Blue Planet Knitwear Ltd.

Mmawna, Mulaid, Polli Biddutroad, Gazipur, Bangladesh

01 April 2014

Observations

Typical Column Layout

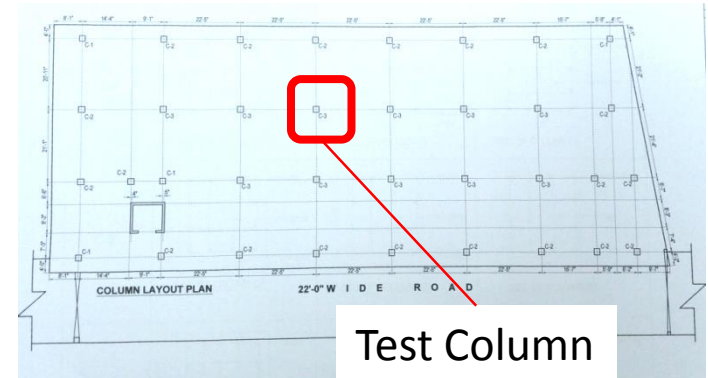
Highly stressed columns due to localised areas of high loads

Preliminary calculations indicate that the working stresses in some columns are at a high level.

Concrete strength to be verified by core testing
Stone aggregate observed.

Tested column at ground level- stone aggregate observed in a number of locations

Typical floor buildup in toilet areas.

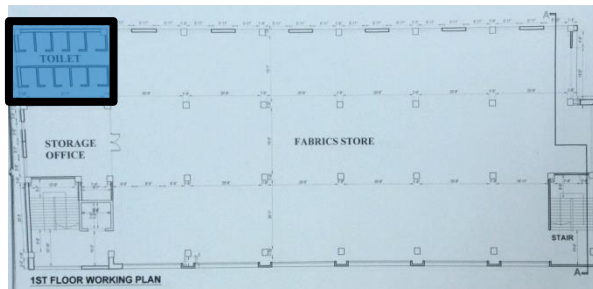
Toilet blocks typically have increased floor build-ups

~130mm additional floor build up in cubicles with a concrete ceiling slab of approx 110mm.

Brick partition walls separating cubicles.

Unused toilet on 1st floor used for additional storage.

Additional storage loading on the 1st floor.

Water Tank Locations

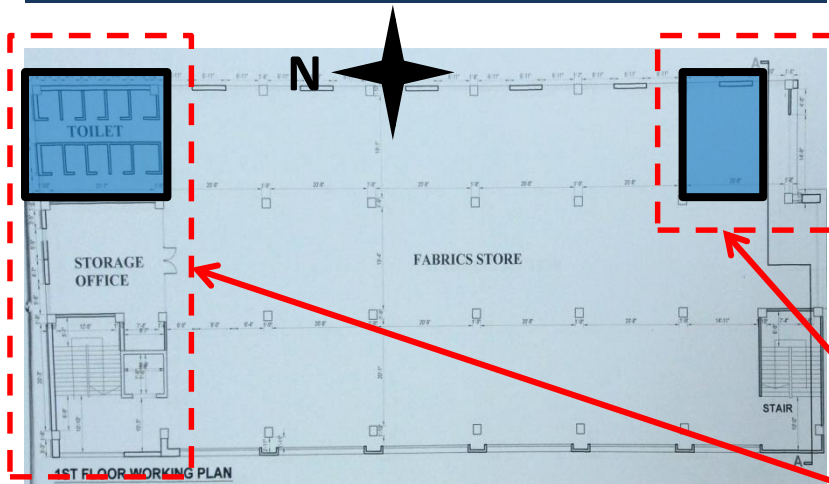
Water tank in north east corner of building located above toilet blocks with heavier loading leading to accumulation of heavy loads in this area.

Water tank at roof level.

Columns in these areas require immediate review due to high loading. Refer to Item 1 action.

**Undocumented single story plant room
annex building.**

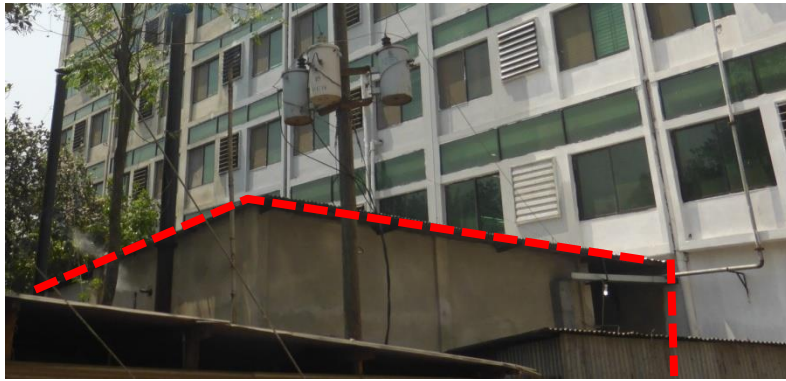
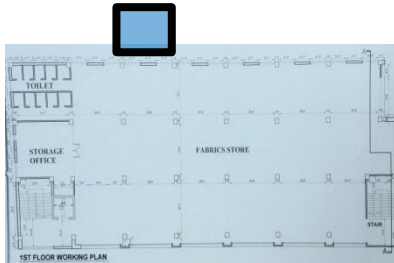
Undocumented single storey plan annex building connected to main production building.

Roof structure appears not to be engineered and is likely to be subject to uplift.
